Re: Updated Minerva Mine Progressive Rehabilitation and Closure Plan (PRCP)

Table 1 – Response to DES Information Request

Progressive Rehabilitation and Closure Plan

Figure 11 – Post-Mining Land Uses

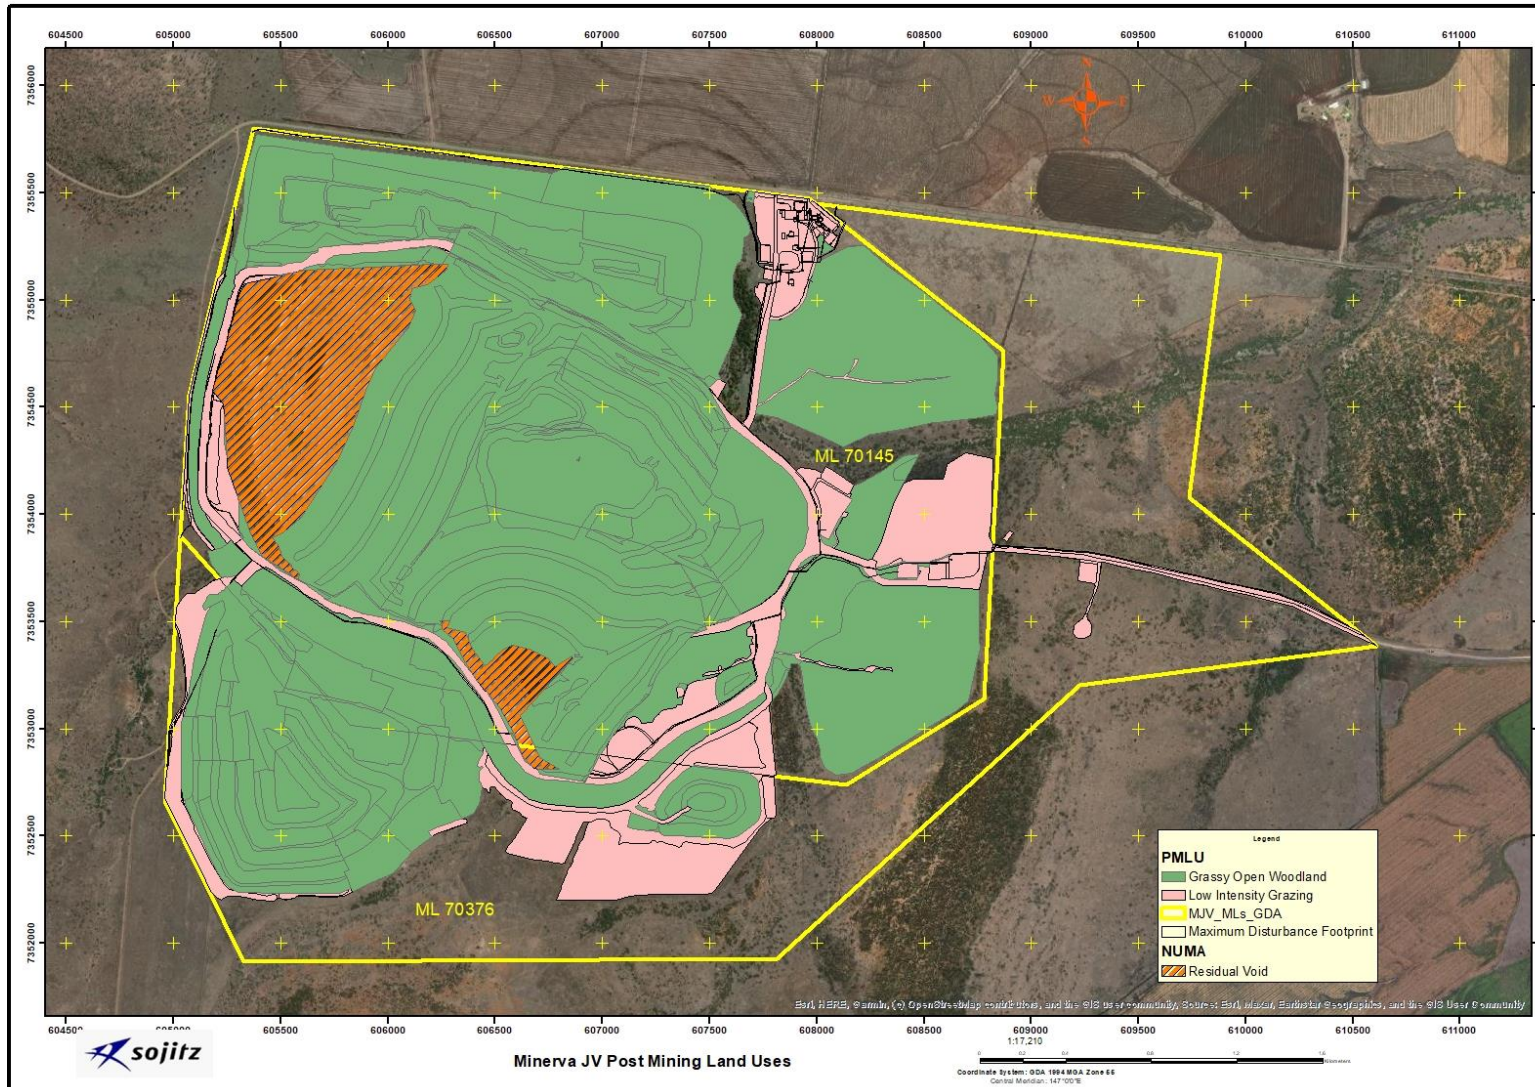
General			
23	Spatial Information	Provide updated spatial files with the removal of overlapping polygons and provide information regarding: 1. Location of sensitive receptors or provide an explanation as to why sensitive receptors have not been included; 2. 0.1% AEP flood zone of the Sandhurst Creek diversion; 3. The discrepancy of the total disturbance and rehabilitation of the site to align with the total area approved by the mining leases.	1. Spatial files for Figure 4 Adjacent Sensitive Receptors has been included within the PRCP files. 2. The modelled 0.1% AEP flood zone for Sandhurst Creek has been provided. 3. Overlapping polygons have been removed and total areas are as follows: Mine Lease 70145 = 931.6ha Mine Lease 70376 = 626.3ha Total ML = 1,557.9 ha Existing rehab area = 451.6ha NUMAs - 89.5ha Proposed Rehab(disturbance) = 530.6ha Total disturbance = 1,071.7 ha
24	Figure 9	Provide an updated map showing the extent and clearly differentiating between the PMLUs.	Figure 9 Post Mining Land Uses has been updated in the PRCP.
